Consideration of BLER method using PMA measurements

Related to comment #307 against D2.2

Xuebo Wang, Guangcan Mi (Huawei)

174A.9.6 BLER method for all lanes using PMA measurements

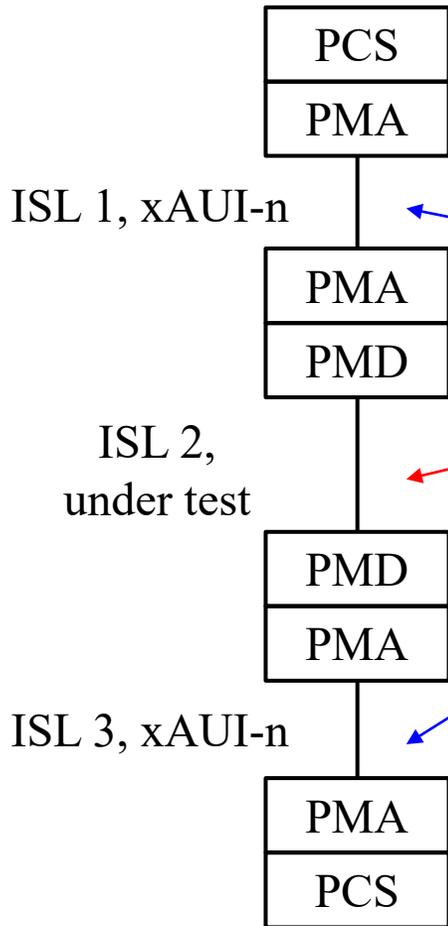
Cl	174A	SC	174A.9.6	P	748	L	12	#	307
Mi,	Guangcan								Huawei Technologies Co., Ltd.
Comment Type	T	Comment Status	R						block error ratio (CK)
									When using Equation (174A-5) to calculate $H_a(k)$, the value of p should be specified to be 1 as $H_a(k)$ is a theoretical histogram without per-lane simulation. $H_a(k)$ should reflect the error distribution over all lanes of an AUI.
									<i>SuggestedRemedy</i>
									Change the sentence "Calculate the error histogram $H_a(k)$ for the added BER using Equation (174A-5) with $BER = BER_{\text{added}}$." to "Calculate the error histogram $H_a(k)$ for the added BER using Equation (174A-5) with $BER = BER_{\text{added}}$ and $p = 1$." Do the same change for Line 33 on Page 748 and Line 10 on Page 751.
									<i>Response</i>
									<i>Response Status</i> C
									REJECT. The current method uses a value of p based on the number of lanes in on the interface. In a real application only a $1/p$ portion of each RS-FEC codeword would appear on each lane. This test method as currently written reflects this reality. Although might be the case that simplifying this approach by setting p to 1 universally would yield the same result, no evidence to this effect has been provided. Evidence to support the proposed change is required.

- $H_a(k)$ should reflect how RS symbol errors are distributed over all lanes of not tested ISLs.
- In step b), there is no convolution of per-lane error histograms to obtain $H_a(k)$ but using 174A-5.
- Using 174A-5 needs to specify both BER_{max} and n (or p). Already have $BER_{max} = BER_{added}$.
- As no convolution is defined, we should additionally specify $n = 544$ (or $p = 1$) when calculating $H_a(k)$ using 174A-5.

- Option 1:
 - Change step b) “Calculate the error histogram $H_a(k)$ for the added BER using Equation (174A–5) with $BER_{max} = BER_{added}$ ” to “Calculate the error histogram $H_a(k)$ for the added BER using Equation (174A–5) with $BER_{max} = BER_{added}$ and $n = 544$ ”.
- Option 2:
 - Change step b) “Calculate the error histogram $H_a(k)$ for the added BER using Equation (174A–5) with $BER_{max} = BER_{added}$ ” to “Calculate the error histogram $H_a(k)$ for the added BER using Equation (174A–5) with $BER_{max} = BER_{added}$ and $p = 1$ ”.
